IMPORTANT NOTICE

1/2" (13mm) A-1337 Lok-A-Loy Connecting Links, PN 1015136

With Production Identification Code (PIC) of 9UB, shipped from 4/27/18 to 8/31/18.

Figure 1 - PIC Location

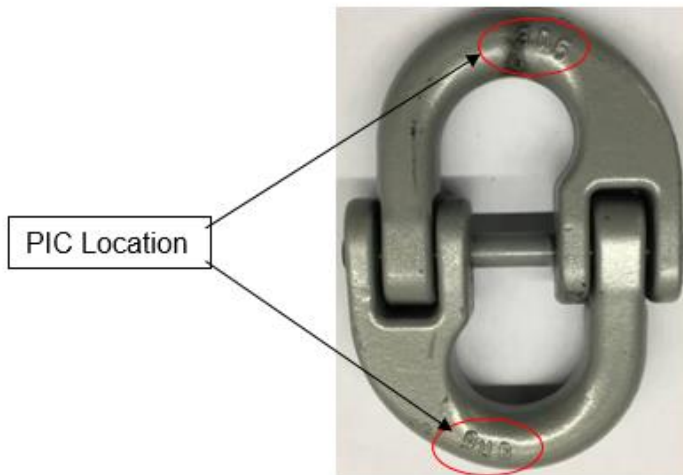
THE CROSBY GROUP has determined that a small percentage of the above listed 1/2" A-1337 Lok-A-Loy 10 Connecting Link Assemblies may have an oversize hole condition that can cause pin fracture during proof load testing. While we are confident these products will perform as intended when used within their working load limits, Crosby is committed to ensuring our products go above and beyond our industry-leading safety standards. Because there is a possibility that a small percentage of these products may not reach Crosby's targeted 4X design factor (4 times the working load limit), Crosby has decided to initiate this Important Notice. By use of the Production Identification Code (PIC) symbols which appear on the product, we have identified the 1/2" Lok-A-Loy Assemblies of PIC 9UB that may be affected. See *Figure 1* below indicating the position of the PIC symbol upon the 1/2" Lok-A-Loy connecting link.

We are requesting you identify all such 1/2" Lok-A-Loys with PIC 9UB, and either: (1) arrange for return and replacement; or (2) inspect to confirm the oversize hole condition does not exist. Determining if the oversize hole exists requires disassembly of the link assembly using a 3/8" punch, and measurement of hole diameter of single ear of link. See *Figure 2* below. The hole diameter is considered oversize and unusable, if larger than 0.410" (10.41mm).
